Access Compliance Report Public Rights-of-Way (Curb Ramps)

Main Street: SADDLERY_RD Cross Street: LEMON_HEIGHTS_DR Location: NE

ADA ID: RPRK211014111334 Ramp Type: Type 6 - Directional 1 Initial Pass/Fail: Fail Overall Compliance: No Severity Score: 30

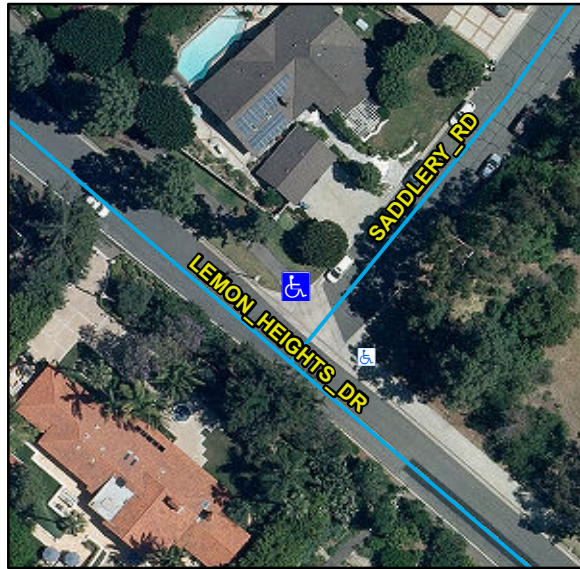
R304.2.2, STD 1115

Compliance	Description	Data	Compliance	Description	Data
N/A	Ramp Length (in)	135	N/A	Flare Type LT	
Yes	Ramp Width (in)	90			N/A
No	Ramp Run Slope (%)	17.2	N/A	Flare Slope LT (%)	N/A
Yes	Ramp Cross Slope (%)	0.6	N/A	Flare Traversable LT	N/A
N/A	Grade Break	N/A	N/A	Flare Type RT	
N/A	Grade Break Slope (%)	N/A			N/A
N/A	Grade Break Cross Slope (%)	N/A	N/A	Flare Slope RT (%)	N/A
	Addl Para Ramp Left?	No	N/A	Flare Traversable RT	N/A
	Addl Para Ramp Right?	No	N/A	DWS Provided	N/A
N/A	Landing Present	N/A	N/A	DWS Contrast	N/A
N/A	Landing Length (in)	N/A	N/A	DWS Length (in)	N/A
N/A	Landing Width (in)	N/A	N/A	DWS Full Width	N/A
N/A	Landing Run Slope (%)	N/A		DWS Offset Type	N/A
N/A	Landing Cross Slope (%)	N/A	N/A	DWS Left Offset (in)	N/A
N/A	Landing Movement Obstructed?	N/A	N/A	DWS Right Offset (in)	N/A
	Landing Movement Type	N/A			
N/A	Landing Shared	N/A			
N/A	Marked Crosswalk 1	No	N/A	Clear Space	N/A
	Crossing 1 Direction	SE	N/A	Clear Space To Crosswalk (in)	N/A

Remove & Replace Entire Ramp.
